## Amendments to the Drawings:

Title: Differential and Differential Case Inventors: WATANABE et al. et al. App. No.: 10/780,587 Docket No.: 023971-0377

ANNOTATED SHEET

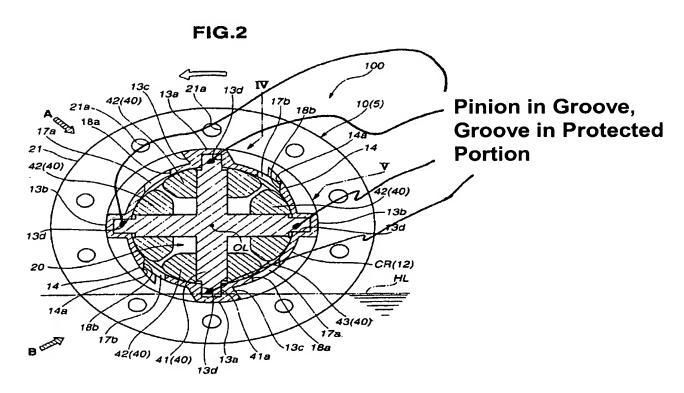
The Office Action asserts that, referring to Fig. 4 of Porsche, element 17 (identified as a vane) corresponds to the first projected portions of claim 1 and that the openings 18

correspond to the oil inlet opening of claim 1. It is further asserted that the angle of the surface of element 17 of Porsche is an acute angle. However, the feature of "first projected portions formed on an outer surface of the differential case at portions that support . . . pinion shafts through grooves, where the grooves and the projected portions are defined as detailed in claim 1, is not present in Porsche. As is clear from the figure from Porsche reproduced in the Office Action, elements 17 are not hollow, and thus cannot have any grooves which receive therein pinion shafts. Accordingly, Porsche does not and cannot anticipate claim 1 for at least this reason.

## **FIG.4(B)**

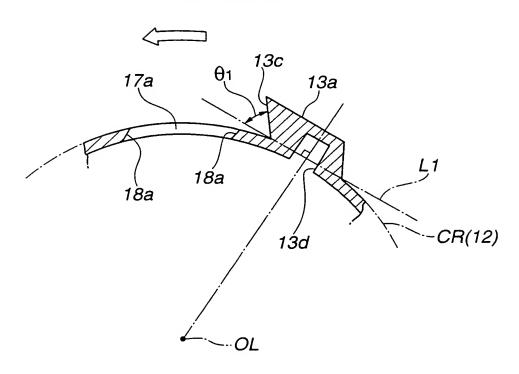
The specific changes which have been made to Figure 4(B) is the incorporation of an angle symbol along with the identifier " $\theta_3$ ".

In the Office Action, the drawings are objected to as allegedly failing to show every feature present in the claims.

The amendment to Fig. 4(B) introduces the angle symbol along with the identifier " $\theta_3$ ", and clearly identifies an obtuse angle as defined by the angle between surface 18a and the tangential line L2.

Please replace the drawing sheet bearing Fig. 4(A) and Fig. 4(B) with the corresponding revised drawing sheet presented in Appendix A of this paper.

In response, in order to advance prosecution, and without prejudice or disclaimer, Applicants have amended Fig. 4(B) as shows above, and also amended claim 9 as show above, and request reconsideration.
